Fluid End - Caged Cover Nut Assembly for Small Bore Fluid Ends

600, 1000, 1300 bhp pump fluid ends for 2.75" and 3.00" plungers:

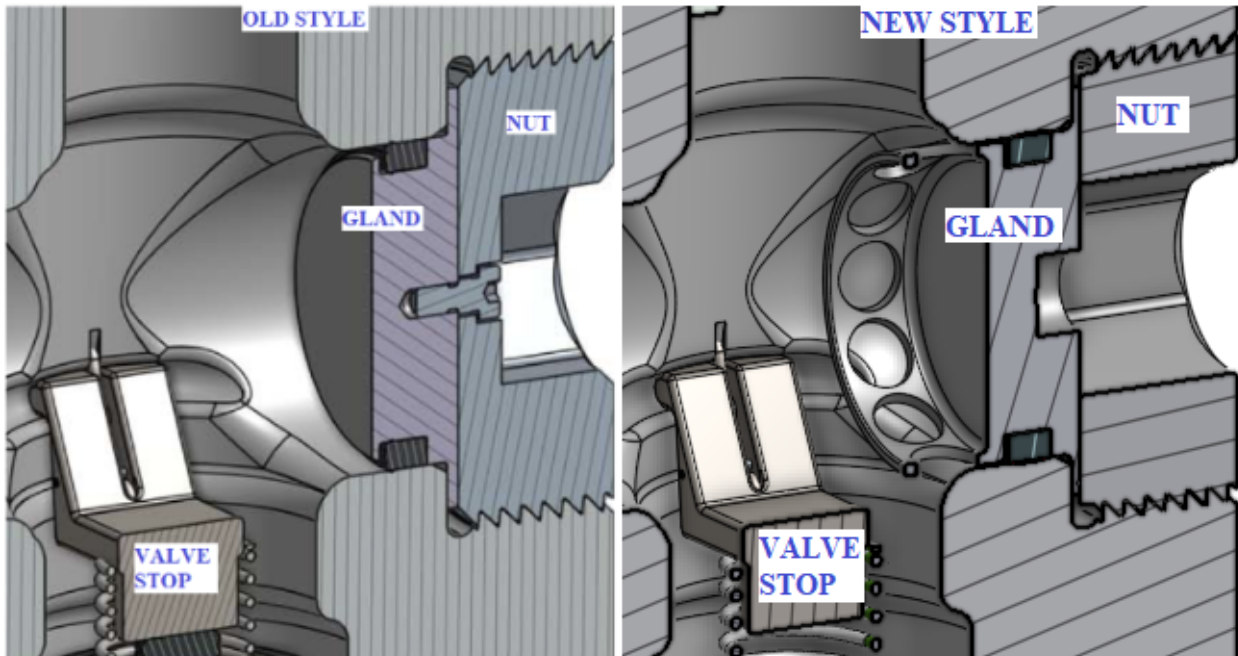
A revised version of the suction cover nut will be provided on all new 2.75" and 3.00" plunger pump and fluid end assemblies as of March 2023. A cage integrated with the seal gland piece provides further protection against valve stop rotation. The suction cover assembly [gland+nut+seal] can be ordered as FEC0565.

old style	new style
valve stop	FEC0382	
gland	FEC0338	FEC0562G
nut	FEC0339	FEC0562N
seal	FEC0095	FEC0095-D
